Access Compliance Report

Public Rights-of-Way

Intersection ID: 11511	Main Street: E_18TH_ST	Cross Street: N_DAVIDSON_ST	Location: S
ADA ID: C768F8FCB1B5	Ramp Type: PerpDiag	Initial Pass/Fail: Fail	Overall Compliance: No
Severity Score: 13.75			
Codes/Mitigation Info/Possible Solution		Field Measurements/Component Compliance

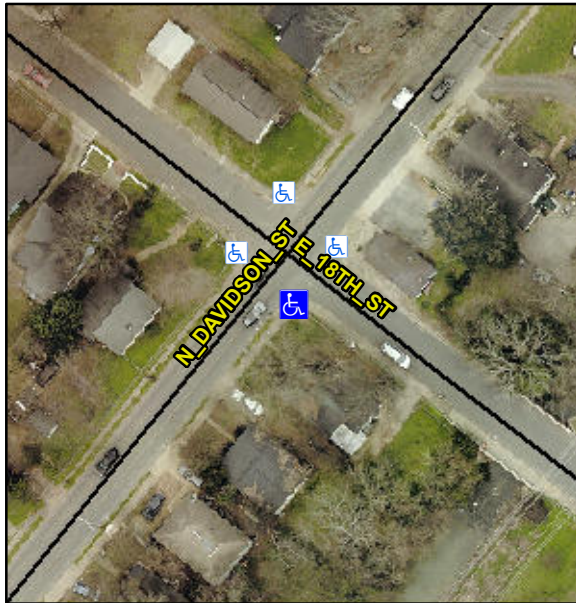
Not Found, R304.2.2, R304.5.3

Compliance	Description	Data	Compliance	Description	Data
N/A	Ramp Length (in)	70.0	No	Ramp Slope (%)	10.6
Yes	Ramp Width (in)	50.0	No	Ramp XSlope (%)	3.9
N/A	Flare Type LT	N/A	N/A	Flare Type RT	N/A
N/A	Flare Slope LT (%)	N/A	N/A	Flare Slope RT (%)	N/A
N/A	Flare Traversable LT?	N/A	N/A	Flare Traversable RT?	N/A
N/A	Landing Length (in)	N/A	N/A	DWS Provided?	N/A
N/A	Landing Width (in)	N/A	N/A	DWS Contrast?	N/A
N/A	Landing Slope (%)	N/A	N/A	DWS Length (in)	N/A
N/A	Landing X Slope (%)	N/A	N/A	DWS Full Width?	N/A
N/A	Landing Curb? (Y/N)	N/A	N/A	DWS Offset (in)	N/A
N/A	Shared Landing?	N/A			
N/A	Gutter Ponding?	N/A	N/A	Gutter Slope (%)	N/A
N/A	Gutter Lip Ht (in)	N/A	N/A	Gutter X Slope (%)	N/A
N/A	Painted X Walk1?	No	N/A	Painted X Walk2?	No
	X Walk 1 Direction	To NE		X Walk 2 Direction	To NW
N/A	X Walk 1 Width (in)	N/A	N/A	X Walk 2 Width (in)	N/A
	X Walk 1 Slope (%)	2.0		X Walk 2 Slope (%)	6.3
	X Walk 1 X Slope (%)	6.5		X Walk 2 X Slope (%)	0.1

N/A	Ramp inside XWalk1?	N/A	N/A	Ramp inside XWalk2?	N/A
	Road Slope (%)	3.2	N/A	Clear Space?	N/A
	Road X Slope (%)	3.4	N/A	Clear Space to XWalk (in)	N/A
N/A	Any Obstructions?	N/A	N/A	Storm Grate/Utility Hazard?	N/A
	Obstruction Type			Storm Grate/Utility Type	
		N/A			N/A
		Yes		Surface Condition? (G/P)	Good

Remove & Replace Curb Ramp With Two New Directional Ramps or Equivalent.
